# Attachment A: Issue No 1 - Adequacy of view assessment

# Attachment B: Issue No. 2 - Built form massing

# Attachment C: Issue No. 3 - Podium facade design quality

### Recommendation: Potential alternative tower form

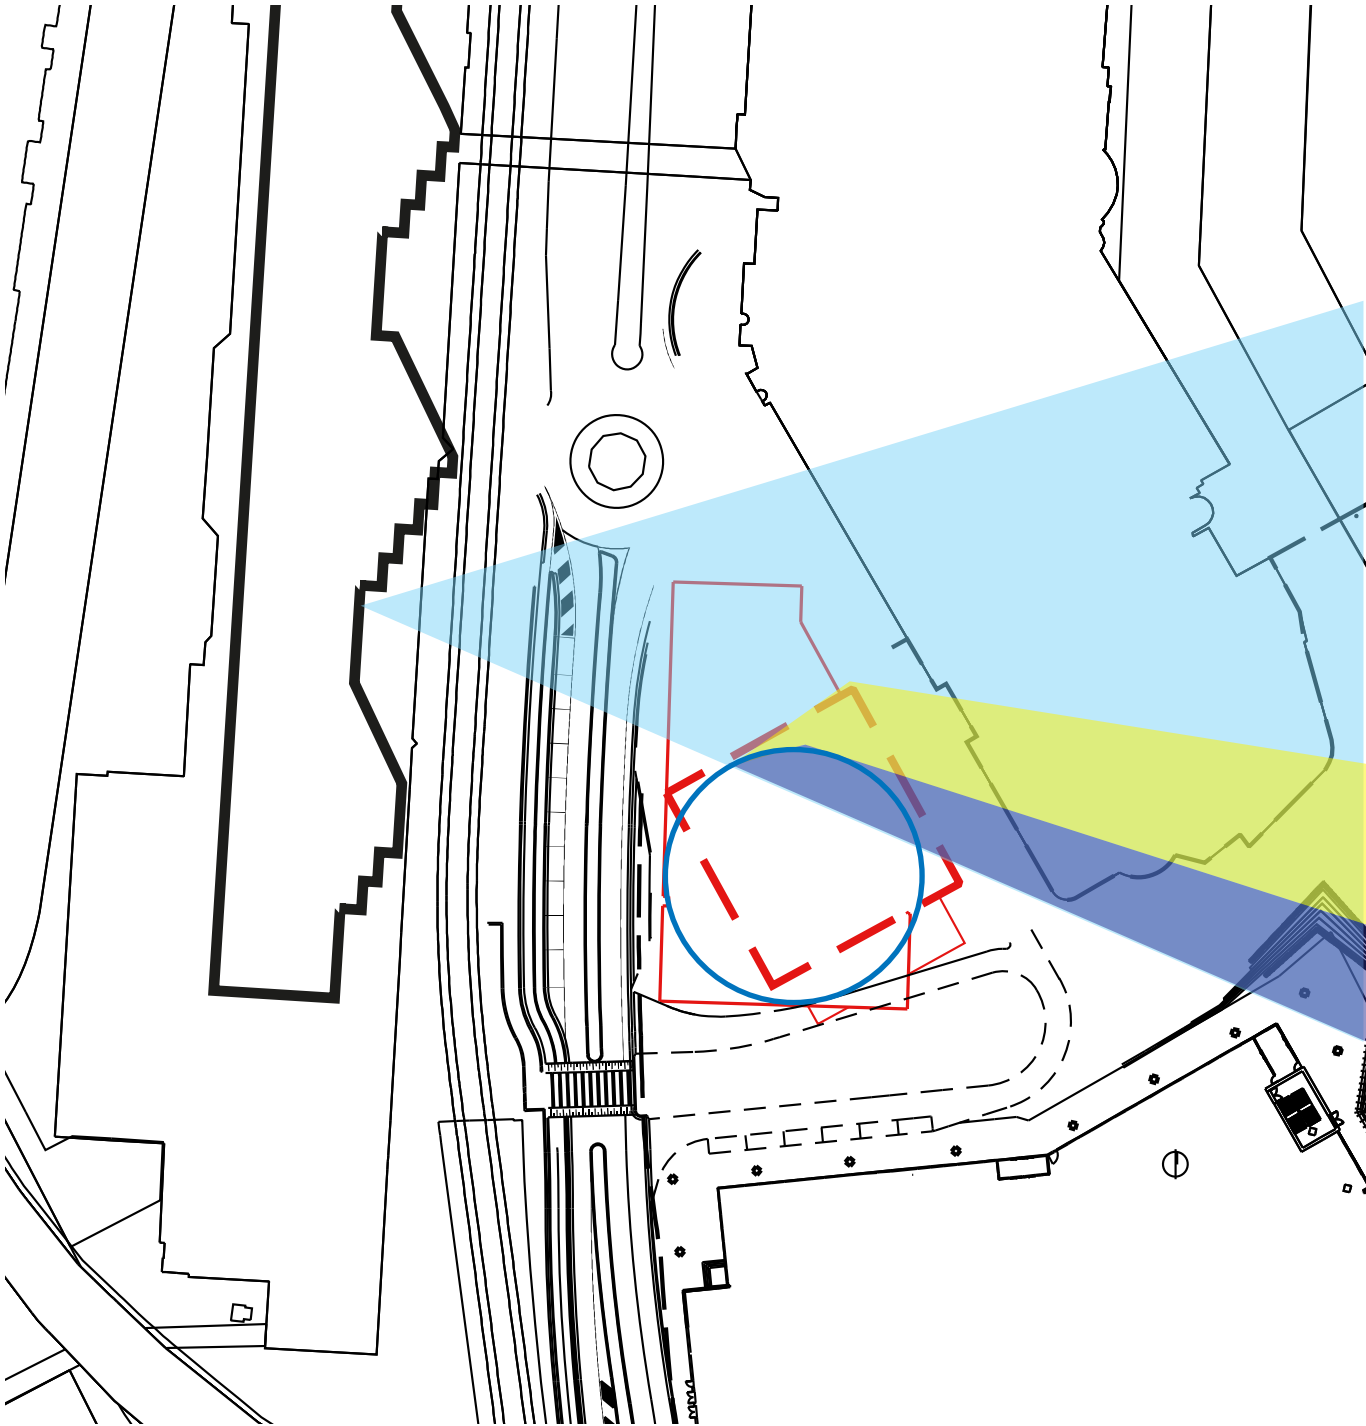
The tower form has **not been designed to minimise its impact on views**. The tower form could be arranged with an identical footprint to minimise its visual impact on the Novotel through:

- Adopting a circular, or less regular form which reduces the visual width of the building.
- Moving the tower bulk further to the southwest, where fewer views are affected.
